CADENCE 19TH/FIR

119 19th Ave, Seattle, WA

Cadence Real Estate
Recommendation Package
11/19/2020
SDCI #: 3034218

1 BUILDING MASS AND SCALE - Further evolution of approved design

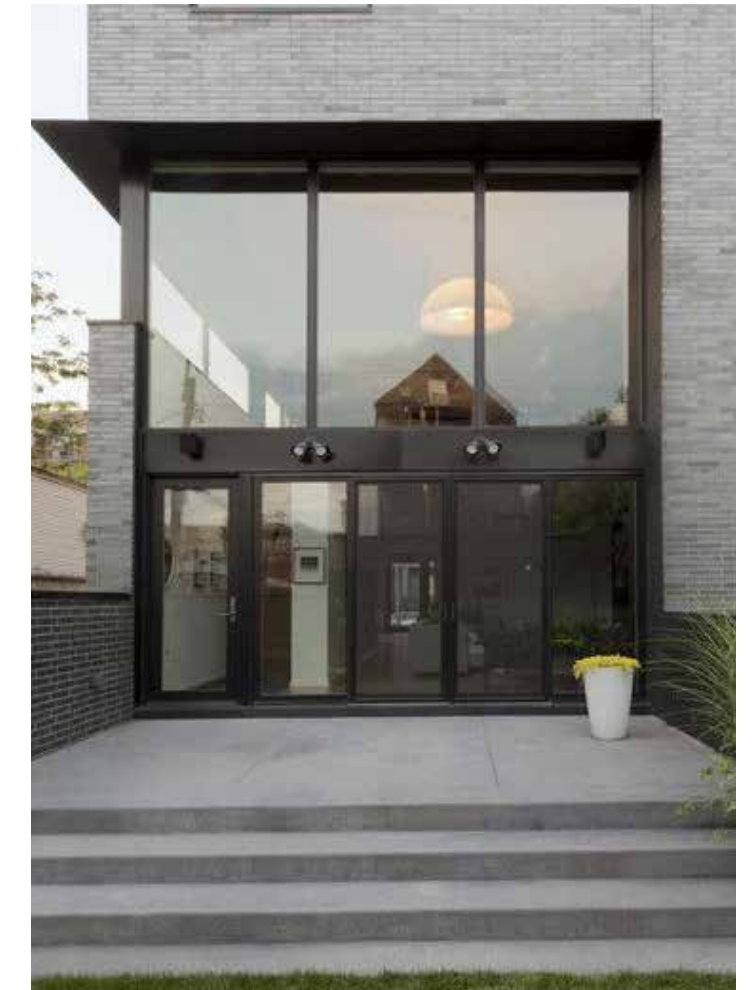
a. The Board supported the applicant's further design of the building massing, height, and scale. The Board found the updated design responded well to Board guidance from the initial Early Design Guidance meeting. (CS2.C.1, DC2-1.a.b.e)

The team appreciates the support from the board on the massing choices and will continue to evolve the design while keeping this in mind as a priority.

3 CULTURAL RESOURCES/NEIGHBORHOOD CONTEXT

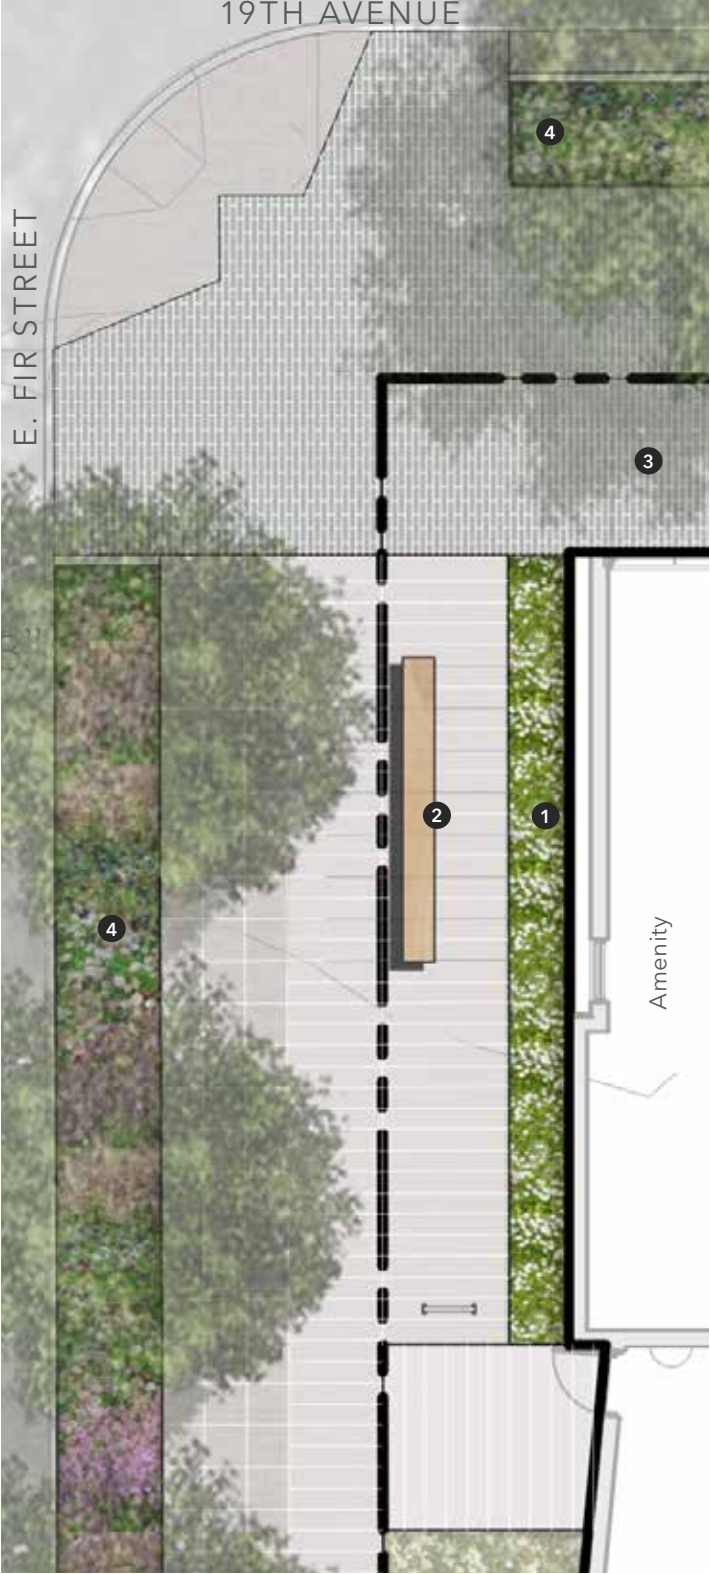
- a. The Board again emphasized and encouraged the applicant to reach out to other community groups in the Central Area neighborhood to assist with establishing appropriate wayfinding at the development and introducing art or other placemaking pieces that reflect the African American heritage of the Central District. The Board noted that outreach to cultural experts in African American heritage is appropriate for new developments in the neighborhood, in response to cultural and placemaking design guidelines. (A.1-1, A.2-1)

The Cadence team is proposing to address the community engagement aspect with a corner design feature that integrates “living” design elements such as planting and lighting with graphic references to Central District history the we hope will provide interest as well as a neighborhood focal point. In combination with the ramp element on 19th which offers a casual open space for community interaction, the design feature on 19th/Fir will also support casual interaction, as well as enhanced walkability, “eyes on the street” and a respectful acknowledgement of what has transpired.

4 RESIDENTIAL ENTRY

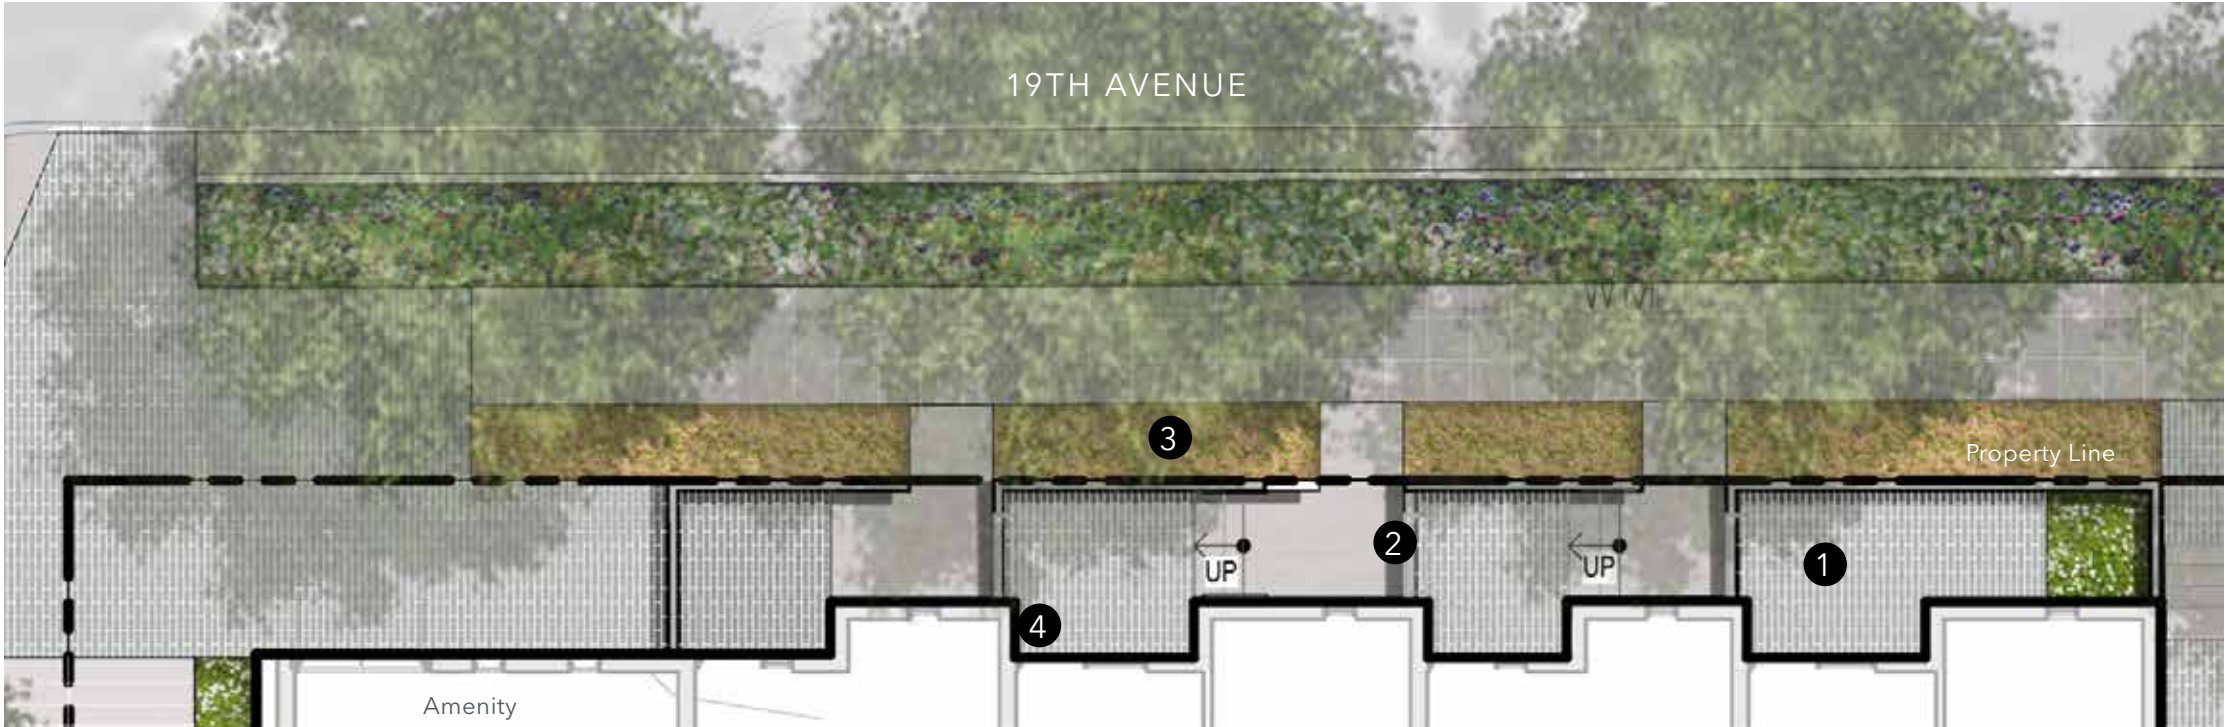
- a. *The Board appreciated the further development of residential entry and lobby off of East Fir Street and 19th Avenue. The Board recommended further detailing of both entries, noting that the details should include amenity features and furniture proposed at each of the entry locations. (PL3.A)*

Promoting community and connection, the design team decided to focus further development of the residential entry to the 19th Ave facade, allowing for a higher quality amenity/lobby area to be the midpoint integrating community and tenants. More project resources can now be devoted to heightening the experience in the main entryway.

DEPARTURE 01

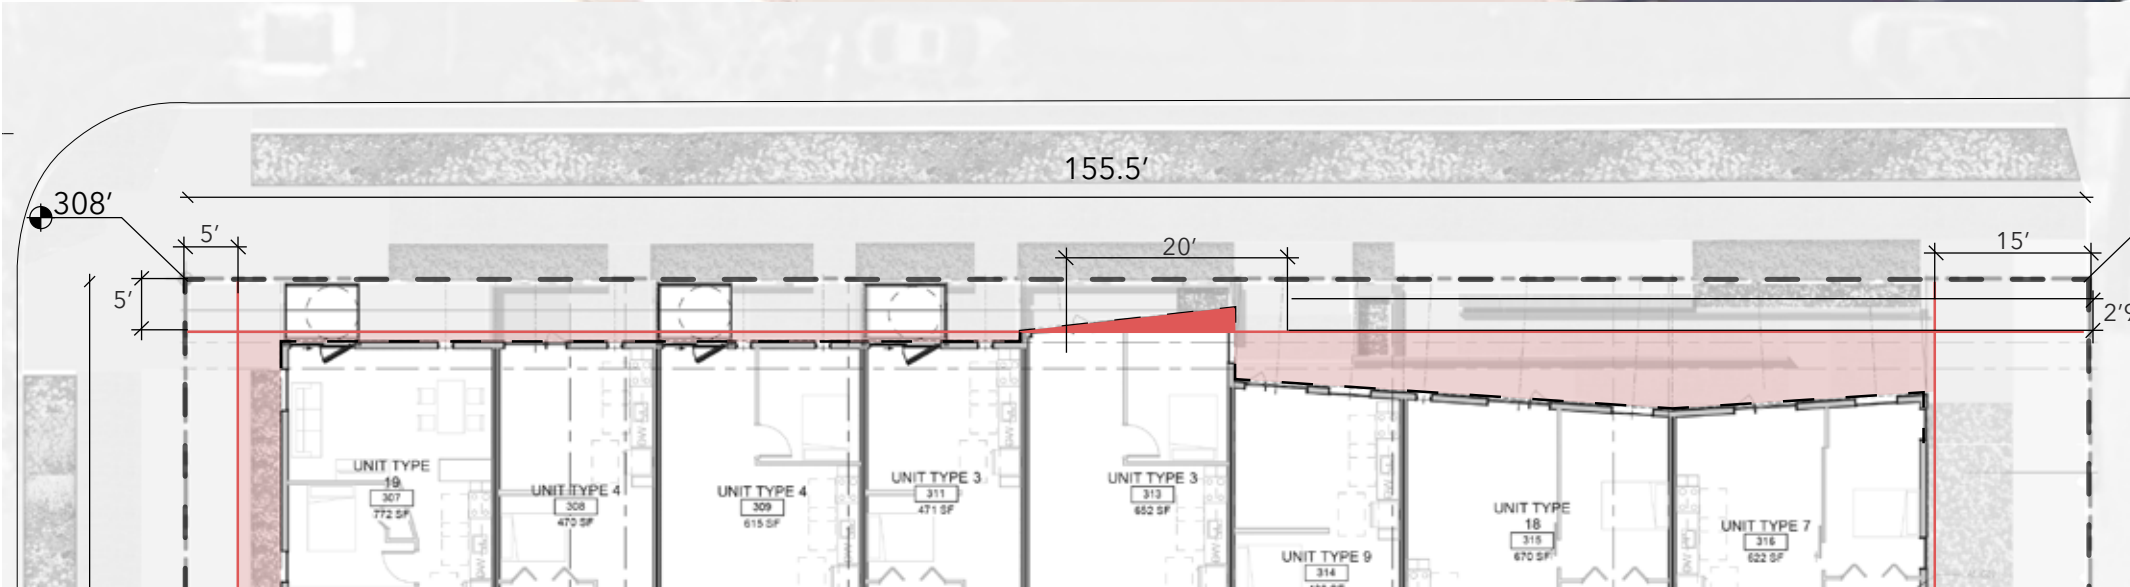
The bay design element along 19th projects into the side yard setback 2.18' which exceeds the 2' maximum. Further, the bay design element is closer than 5' from the 19th st lot line and exceeds 10' in width.

Through EDG and community outreach, it was determined that the existing zoning massing was too rigid and did not allow variation, visibility and legibility of the proposed development along 19th. As a result the team selected Design Guidelines DC 2 "Architectural Concept" for guidance, which identifies the need to "develop a unified functional architectural concept that fits well on the site and its surroundings."

However the team found that a slight outcropping of the building mass to create a projecting bay element will further emphasize the building entry and will provide a more pronounced design feature that is expressive and recognizable, particularly as one walks towards the site heading north from Yesler. This design gesture is not possible utilizing the existing zoning envelope and is consistent with Design Guideline DC-2.
